RECALL: THIS MODIFICATION HAS TOP PRIORITY AND MUST BE PERFORMED IMMEDIATELY TO ENSURE CUSTOMER SAFETY

FUEL TANK CAP SEAL REPLACEMENT

AFFECTED MODELS:

2024 250 DUKE

Fig. 1: Collar metal ring

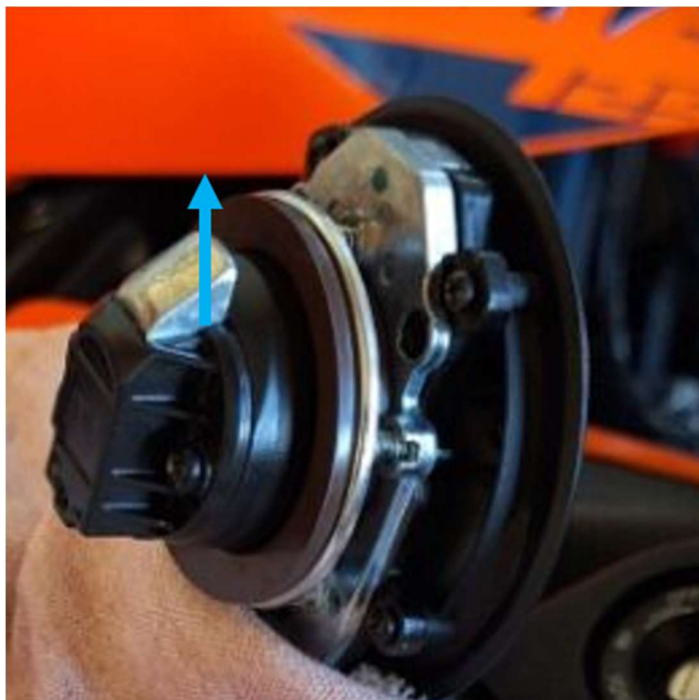
- Seal carrier incl. Remove and disassemble the seal and metal ring.
- Replace seal.
 - Attention:** Ensure that the sealing lip of the new seal is seated correctly and that the metal ring is aligned correctly - the collar of the metal ring must point away from the seal, see Fig. 1.
